Proposed Comment Resolution related to 127.2.6, 2.5GBASE-X PCS

**Comment #: 335~354 (DL), 228~233 (BM),
LateCommentsDL1~18, etc
Pages 62~ 91 of D2.0 PDF (61~92 extracted)**

Edited by Yong Kim

Broad brush response (Late Comment 6-Pg2)

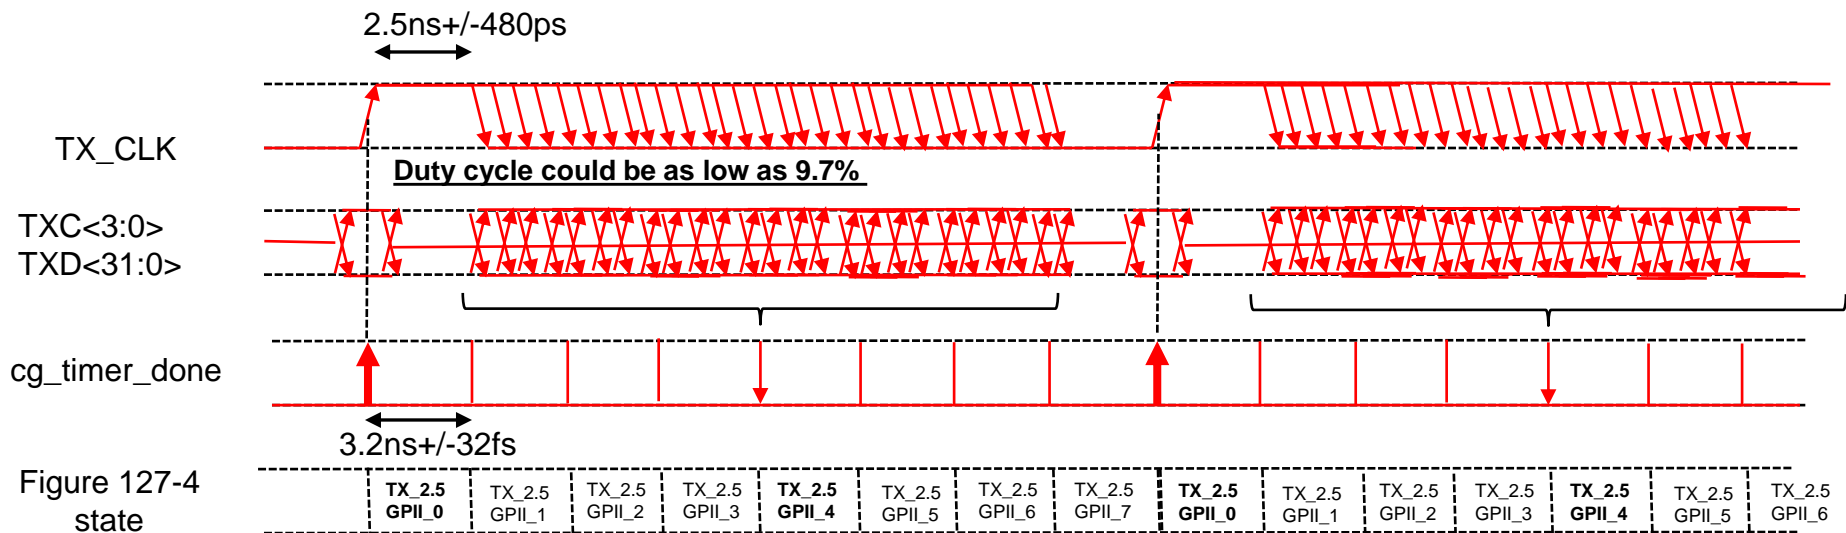
- **DLLC6** — "According to the XGMII TX_CLK specification and Figure 46–16 'TX_CLK and RX_CLK timing parameters' the XGMII TXC and TXD signals are only valid for 480ps before and after the rising and falling edge of TX_CLK, and the minimum pulse width for TX_CLK is 2.5ns. As far as I can see these specifications are not changed by IEEE Std 802.3bz-2016 when 2.5 Gb/s and 5 Gb/s operation is added to the XGMII and therefore a TX_CLK clock duty cycle as low as 9.7% seems to be permitted for 2.5Gb/s operation. This seems to present a problem for Figure 127–4 'PCS Word Encode and Word-to-Octets state diagram' as it will take four cg_timer_done, which is 12.8ns, between samples of TXC<3:0> and TXD<31:0> in the TX_XGMII state, please see figure IEEE_P802d3cb_D2p0_David_Law_clock.pdf attached to this comment."

- Latching of TXC<3:0> and TXD<31:0> has to occur both on the rising and falling edge of TX_CLK.
- Resolution: Create two sets of new definitions - xgmii_txc<3:0> and xgmii_txd<31:0>, to be latched on the rising edge of TX_CLK, and xgmii_txc_lo<3:0> and xgmii_txd_lo<31:0>, to be latched on falling edge of TX_CLK. And replace TXC<3:0> and TXD<31:0> with xgmii_txc<3:0> and xgmii_txd<31:0> in the Fig 127-4 state diagram and also in WENCODE() function. The cg_timer is only synchronized with the rising edge of TX_CLK. (changes in 4 parts), and data latched with falling edge of TX_CLK (xgmii_txc_lo and xgmii_txd_lo) is sent on TX_2.5GPIL_0~3 states (after buffered and encoded) and data latched with rising edge of TX_CLK is sent on TX_2.5GPIL4~7 (likewise)

Figure 127-4—PCS Word Encode and Word-to-Octets state diagram

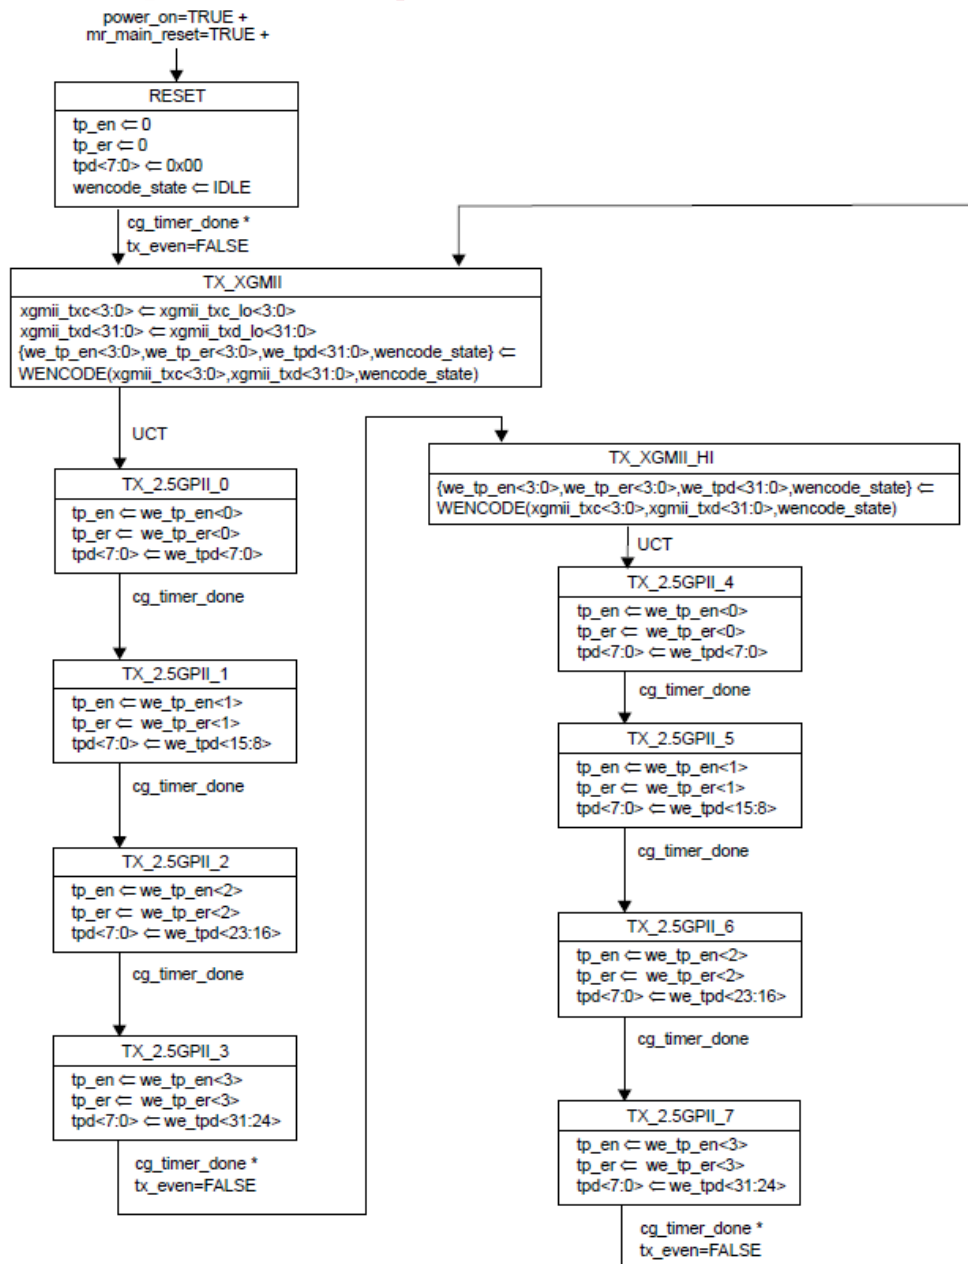
DL-LC6: "... This seems to present a problem for Figure 127-4 'PCS Word Encode and Word-to-Octets state diagram' as it will take four cg_timer_done, which is 12.8ns, between samples of TXC<3:0> and TXD<31:0> in the TX_XGMII state..." "Latching of TXC<3:0> and TXD<31:0> has to occur both on the rising and falling edge of TX_CLK." See timing diagrams from DL. - LC6 responses are in 4 parts. DLLC6-p1~p4

Figure 127–2—Functional block diagram

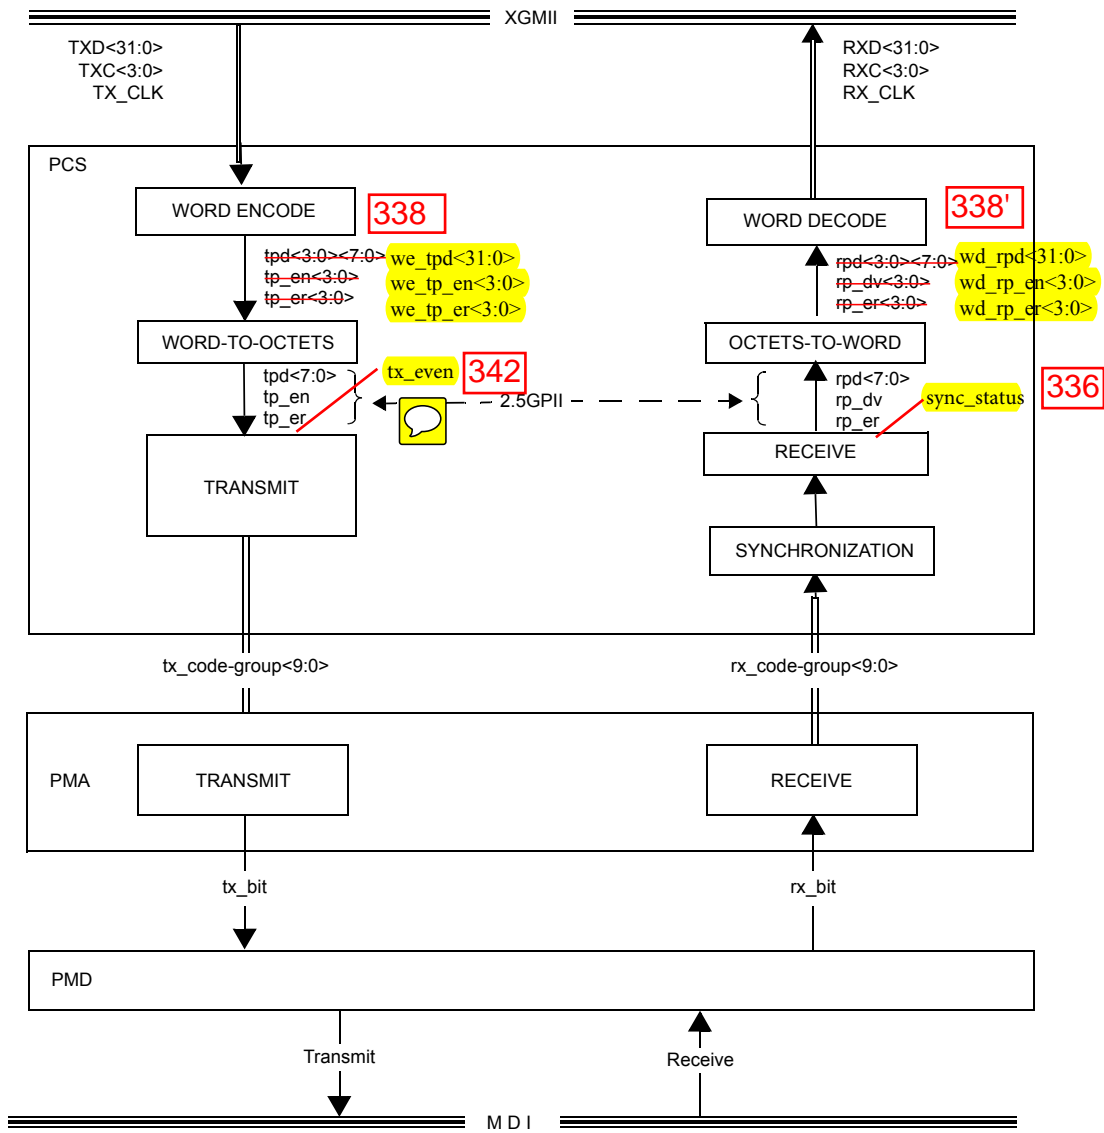
- 136 – DS – SIGNAL_DETECT – should be rejected (comment response says “proposed accept”).
- 335 DL – sync_status variable def correction.
- 336 DL – add tx_status to 2.5GPII interface in Fig 127-2 (and remedy seems to be wrong (refers to sync_status). So change to accept in principle.
- 337 – DL – Add values FAIL and OK definitions.
- 339 – DL – reference correction ... running disparity.
- 231 – BM – editorial “SUDI...EEE....”
- 232 – BM – 287 – CD - editorial “NEXTSEQ()”
- 233 – BM – 137 – DS - editorial “Signal_de..” to “signal_de...”
- 340 - DL – TX_CLK on XGMII
- 341 - DL – Editorial improvements on 127.2.6.1
- 342 – DL – tx_even to 127-2
- 343 – DL – PCS Word Encode SD
- 346 – DL – IF THEN ELSE (capitalize)
- 3 – ML – Editorial Improvements on Fig 127-5 PCS TX State Diagram
